## OFFICE OF NEW REACTORS

### ASSESSMENT OF WHITE PAPER SUBMITTALS ON DEFENSE-IN-DEPTH, LICENSING BASIS EVENT SELECTION, AND SAFETY CLASSIFICATION OF STRUCTURES, SYSTEMS AND COMPONENTS

#### NEXT GENERATION NUCLEAR PLANT

##### PROJECT 0748

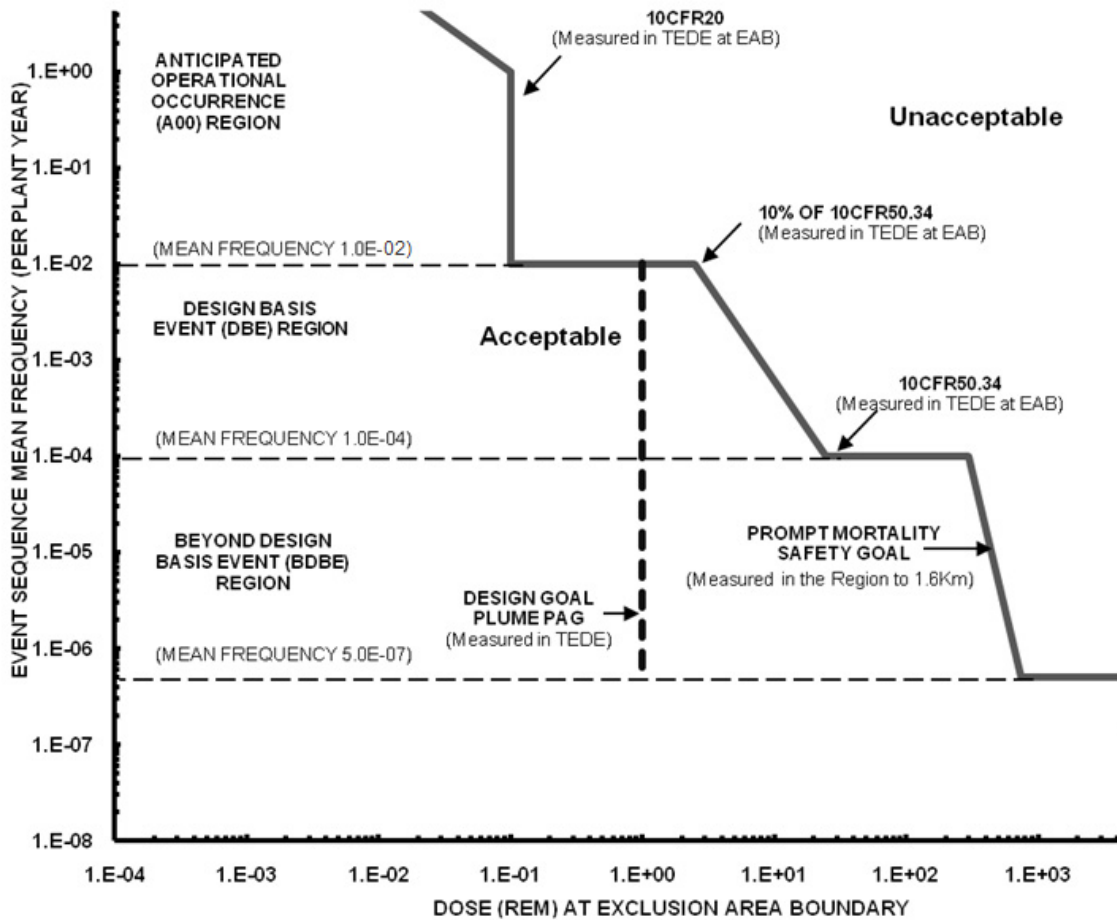
The event frequency versus dose consequence acceptance line shown in this figure is generally referred to as an “F-C curve.” For events in the AOO frequency region, the proposed F-C curve has been constructed based on the dose limits in 10 CFR Part 20. For events in the DBE frequency region, the proposed F-C curve has been constructed based on the dose limits in 10 CFR 50.34.<sup>4</sup> For events in the DBE region, the proposed F-C has been constructed such that a reduced dose would be allowed as DBE frequency increases. For the DBAs (which are selected and derived from the DBEs), it is proposed that dose criteria in 10 CFR 50.34 apply (i.e., without reduction). For events in the BDBE frequency region, the proposed F-C curve has been constructed based on the prompt mortality safety goal. It is proposed that the dose limits be associated with and apply at the NGNP exclusion area boundary (EAB).

The working group recognizes that there are a large number of ways to construct an F-C curve that utilizes the dose acceptance criteria of existing NRC regulations and applies them to inferred frequency ranges for the event categories to meet the above stated objectives. For example, the proposed frequency consequence curve shown in Figure 3-3 of NUREG-1860 was developed in connection with the NRC staff's feasibility study for a risk-informed and performance-based regulatory structure for future plant licensing. The F-C curve shown in Figure 3-3 of NUREG-1860 was developed using the same LWR regulations used to develop the F-C curve proposed by the NGNP project. The development of the F-C curve in NUREG-1860 also includes consideration of additional dose acceptance criteria associated with national and international radiological health standards.

The working group believes that the proposed F-C curve and associated dose calculation framework should be revised.
